AMENDMENT TO FACILITY OPERATING LICENSE

Amendment No. 49
License No. DPR-32

Amendment No. 48
License No. DPR-37

ATTACHMENT TO LICENSE AMENDMENT NOS. 49 AND 48

HOT CHANNEL FACTOR NORMALIZED

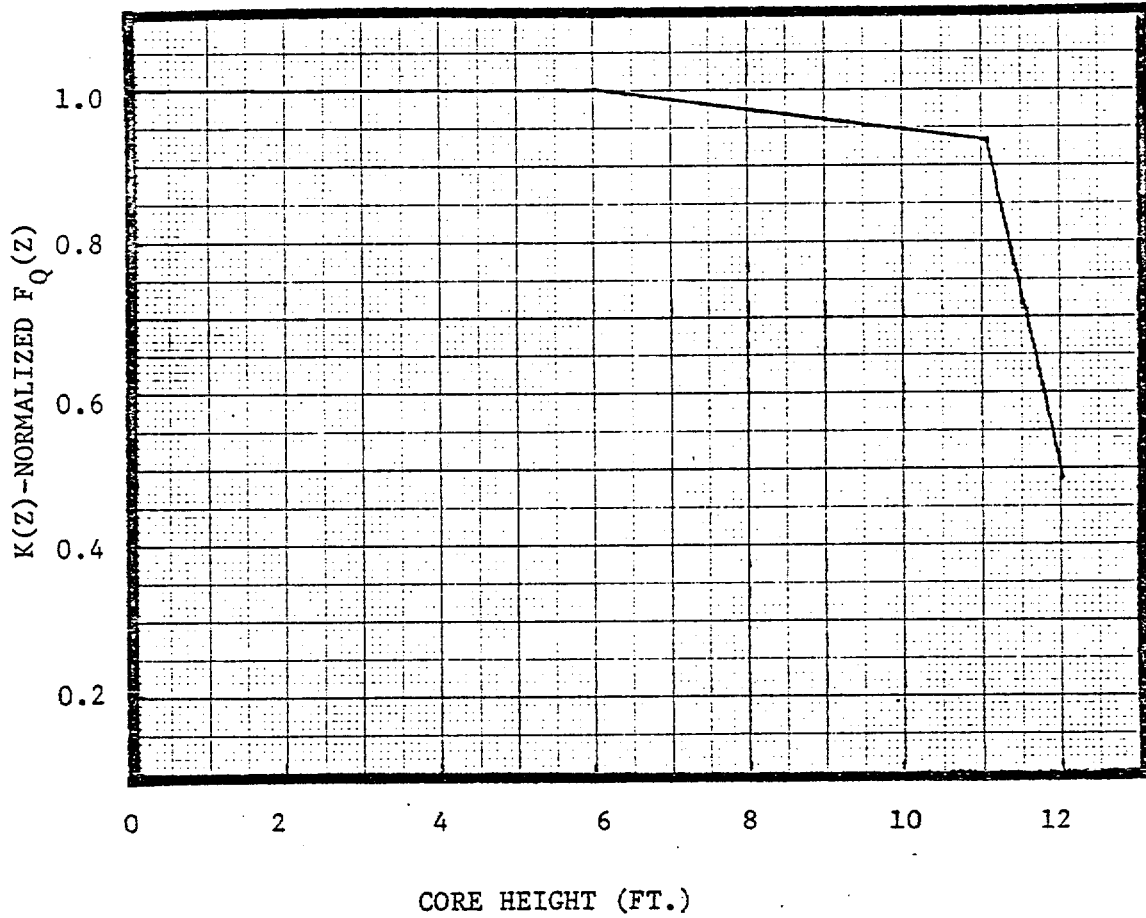
where P is the fraction of rated power at which the core is operating, K(Z) is the function given in TS Figure 3.12-8, Z is the core height location of F_Q, and T(BU) is the interim thimble cell rod bow penalty on F_{ΔH}^N given in TS Figure 3.12-9.

It should be noted that the enthalpy rise factors are based on integrals and are used as such in the DNB and LOCA calculations. Local heat fluxes are obtained by using hot channel and adjacent channel explicit power shapes which take into account variations in radial (x-y) power shapes throughout the core. Thus the radial power shape at the point of maximum heat flux is not necessarily directly related to the enthalpy rise factors. The results of the loss of coolant accident analyses are conservative with respect to the ECCS acceptance criteria as specified in 10 CFR 50.46 using an upper bound envelope of 2.05 times the hot channel factor normalized operating envelope given by TS Figure 3.12-8.

AXIAL FLUX DIFFERENCE LIMITS
AS A FUNCTION OF RATED POWER

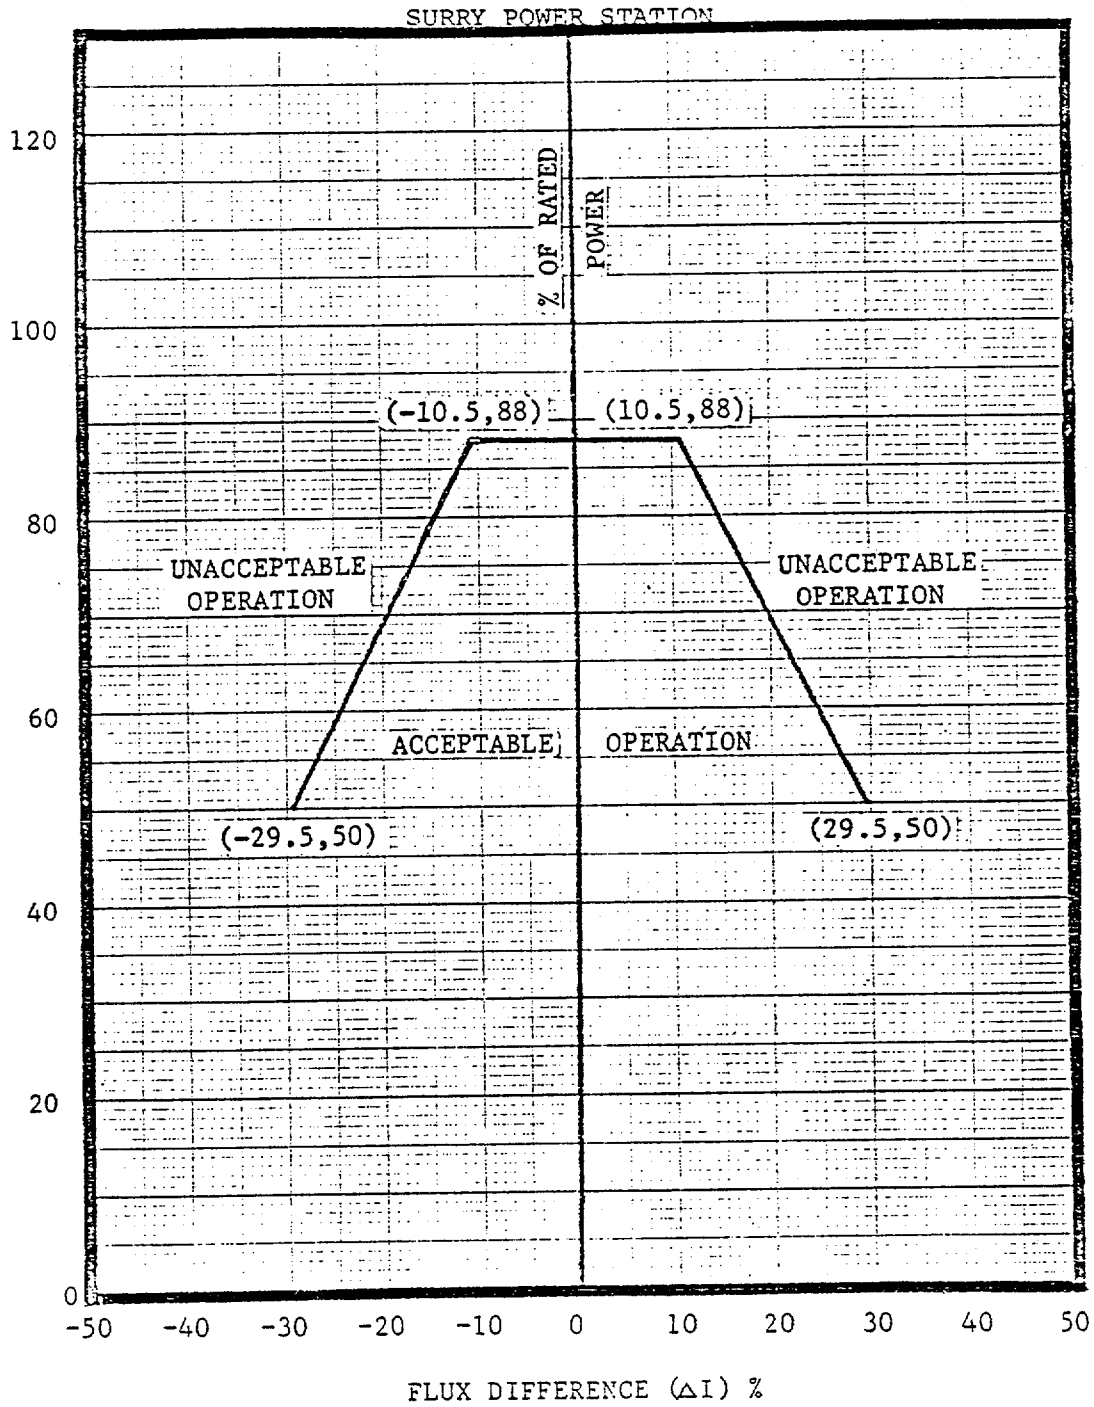
- b. At a power level no greater than 88 percent of rated power,
 - (1) The indicated axial flux difference may deviate from its target band for a maximum of one hour (cumulative) in any 24-hour period provided the flux difference is within the limits shown on Figure 3.12-10.

- (3) New limits for the axial flux difference. This proposed change would specify the new limits for the allowable axial flux difference by: (a) assigning lower value (88%) for the reactor power level above which the axial flux difference must be maintained within a +5% target band; (b) defining the operational conditions for which axial flux difference could remain outside the prescribed limits without reduction of reactor power, and (c) specifying new allowable axial flux difference limits for reactor operation below 88% of its rated power.
